## Executive Director's Recommendation

Commission Meeting: April 5, 2012

Site Improvements and Perimeter Security  
Herbert C. Hoover Building, United States  
Department of Commerce  
1401 Constitution Avenue, NW  
Washington, DC

Approval of comments on concept design

Figure 8: April 2006 Plan for Commerce Building Perimeter Security

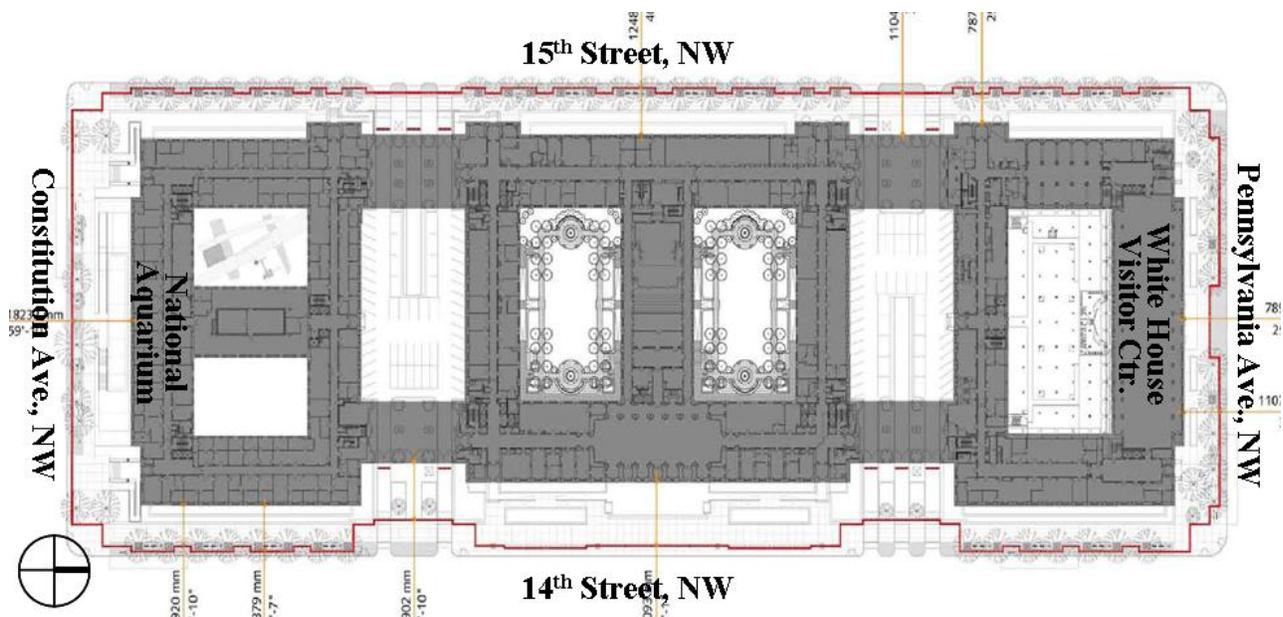
Previous proposal for perimeter security for Commerce Building from April 2006 included security elements approximately 4 feet from the curb. This would have allowed nearly all of the public space to be located within the secure perimeter. Since the current concept proposal has reduced the impact to public space considerably by moving the perimeter security closer to the building, staff recommends that the Commission **commend the General Services Administration for developing a design for perimeter security of a building in the Nation's Capital that is well integrated into the urban fabric of the surrounding streetscape.**

Figure 9: Transitions and variety of elements

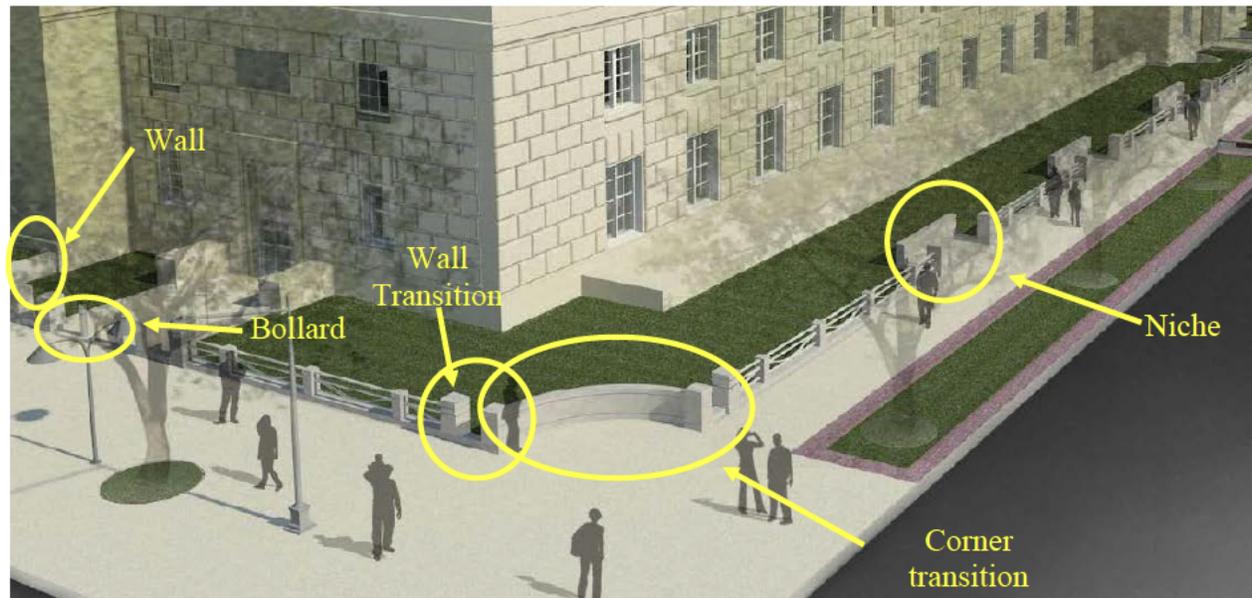
While staff appreciates that GSA has submitted a project incorporating new security standards into the design, the rhythm of the elements and transitions from one element to the next seem a bit cumbersome. For instance, there are many different types of core elements: piers, cables, niches, walls, corners, and bollards. In addition, there are a number of additional elements too such as flag poles, light posts, active vehicle barriers, and the aquarium's south wall which will be a unique feature as well. These various elements make the transitions important.

Subsequent designs should look to simplify the type of elements to reduce the apparent clutter. While it's apparent that some effort was made in the design to mimic the rhythm included in the building façades, a more apparent relationship needs to be established between the perimeter security element placement and the building façades. Exploring this relationship will be important in making a stronger connection between these two elements. In addition, the building architecture should be further analyzed to help identify a horizontal element that will help tie the design together while complementing the architecture itself. These decisions should be explored jointly with DC SHPO, CFA and NCPC staff.

Regarding specific areas, staff has identified the following to be developed further because the transitions are awkward between the various security elements. These transitional areas requiring further design refinement occur around the entire building and affect pedestrian flow, vehicular flow or public space. These recommendations are listed as follows:

- Use a more modern-looking, active vehicular barriers at the vehicular entrances
- Locate the active barriers such that vehicles waiting to be screened will not block pedestrian movements on the sidewalk.
- Allow for barriers be used only at the most active vehicle entrances and use removable bollards at inactive or infrequently-used vehicle entrances
- Incorporate perimeter security into the rear wall of the National Aquarium Entrance Pavilion, rather than the front or south wall, in order to reduce the width of the south wall and its impact on public space.
- Modify the spacing of the security elements at the Pennsylvania Avenue and 14<sup>th</sup> Street sides of the building in order to maximize pedestrian clearances and avoid the creation of narrow, unusable spaces between security elements.
- Evaluate the potential for seating along the walls at the corners of the building.
